Drawing Sheet : R02A

Project: BRIDGE REPLACEMENT #1
CAVENDISH, VT

Drawing: CLOSURE POURS

Customer: COLD RIVER BRIDGES

ABUTMENT 1 CLOSURE POUR

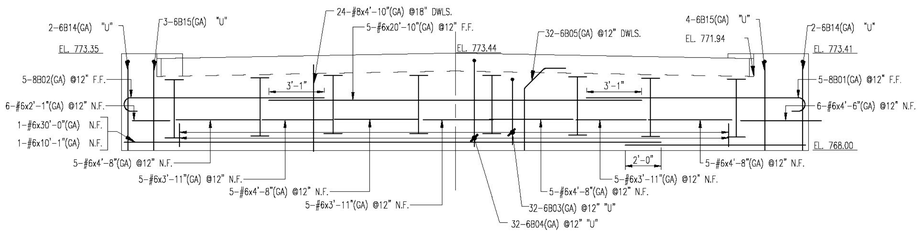
FOR THE 8B01 & 8B02 THE ONLY DIMENSIONS THAT CAN CHANGE IS THE "B" DIMENSION. THE "A" & "J" ARE THE STANDARDS FOR THE BAR SIZE THE 8" "J" DIMENSION IS TO SMALL TO BEND. PLEASE VERIFY IT IS OK TO LEAVE AS IS.
